CITY OF WEST DES MOINES
STAFF REPORT COMMUNICATION

ITEM: Woodland Estates Plat 3, South of the intersection of S. 95th Street and Cascade Avenue – Accept Surety and Approve Final Plat to create 10 lots for Single-Family development, 1 outlot, and 1 street lot – Silo 9 Plat 1, LLC – FP-006164-2023

RESOLUTION: ACCEPT SURETY AND APPROVE AND RELEASE FINAL PLAT

FINAL PLAT

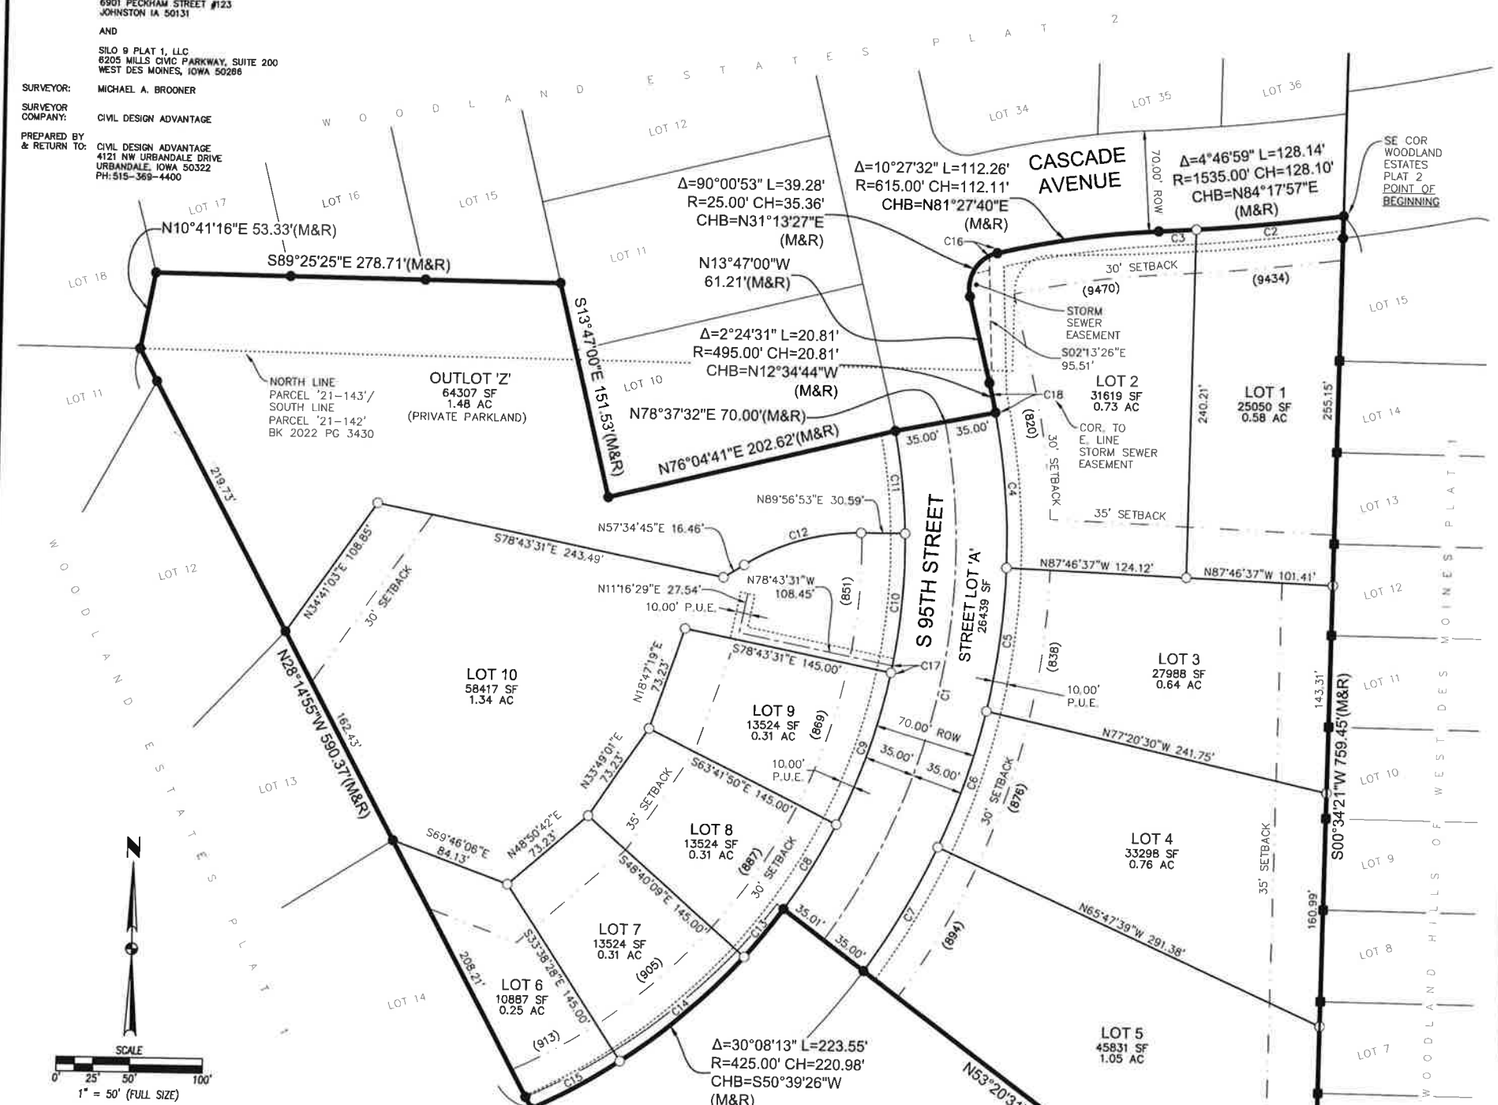
3. Single-family driveways are not recommended on S. 95th Street due to the heavier volumes/speed on the major collector street, as well as the horizontal curve at the south end of the site. Driveways located on S. 95th Street shall be designed to allow drivers to enter onto S. 95th Street via a forward movement. (See following first bullet under Development Aspects.)

- *Development Aspects:*
  - S. 95th Street is classified as a Major Collector. City Code 9-15-6.B.2, "prohibits the backing or backward movement of vehicles from a driveway...onto a major thoroughfare, including all thoroughfares designated as arterial or major collector streets." The anticipated traffic volumes, speed of vehicles and the curve of the road are safety concerns. Those lots fronting S. 95th Street will need to implement a house &/or driveway design in such a manner to allow drivers to utilize a forward movement when entering onto S. 95th Street. A note has been added to the plat drawing and Staff recommends a condition of approval to ensure awareness of this aspect. The developer has indicated that as part of the sale of a lot they will raise awareness of the forward only movement.

- *Public Utility Easements (PUEs):* To reduce the visual clutter of utility boxes and pedestals along roadways, City Code Title 10: Subdivision Regulations, Chapter 3: Design Standards and Required Improvements, Section 2: Improvements, Subsection C1 states: *"Residential Subdivisions: Utility cables shall, as a general rule, be placed at the rear or side of respective lots within an area of perpetual easements reserved for this purpose. Where, in the determination of the council, certain conditions of soil, topography, or other circumstances exist to make the aforementioned easement locations unreasonable or impractical, utility cables may be installed at the front of the lot in an area dedicated for perpetual easement or in the public right of way, provided said installation does not interfere with any other existing or proposed utilities."*

The proposed development area overall is very wooded and is rolling topography with quite a bit of elevation change. While it may be possible to accommodate a PUE in the rear yard on a couple lots, overall, it would be more detrimental to tree preservation and the costs to route utilities back and forth from the front and back and would greatly increase the costs. Therefore, the applicant requests that PUEs be allowed in the front yard of all lots due to the terrain along with the desire to maintain as many trees as possible. Staff is in agreement that there is adequate justification and supports the request for front yard PUEs.

1. The developer acknowledging that vehicles backing out onto S. 95th Street is prohibited. The developer agrees to inform and require buyers of lots that front to and/or access directly to S. 95th Street that all turns onto S. 95th Street must be in a forward movement. Additionally, the developer shall implement measures during the sale of the lot and their approval of a dwelling's layout on the lot to be such to ensure that the design of the garage(s) and driveway accommodates and promote vehicles to be able to orient for forward movement from the lot onto S. 95th Street.

2. The City Council granting allowance of the placement of Public Utility Easements (PUEs) in the front yard of all lots.
3. The developer acknowledging and agreeing that no building permits for any construction shall be issued until vehicle accesses to the satisfaction of the City's Fire Marshal have been constructed and open to the public.
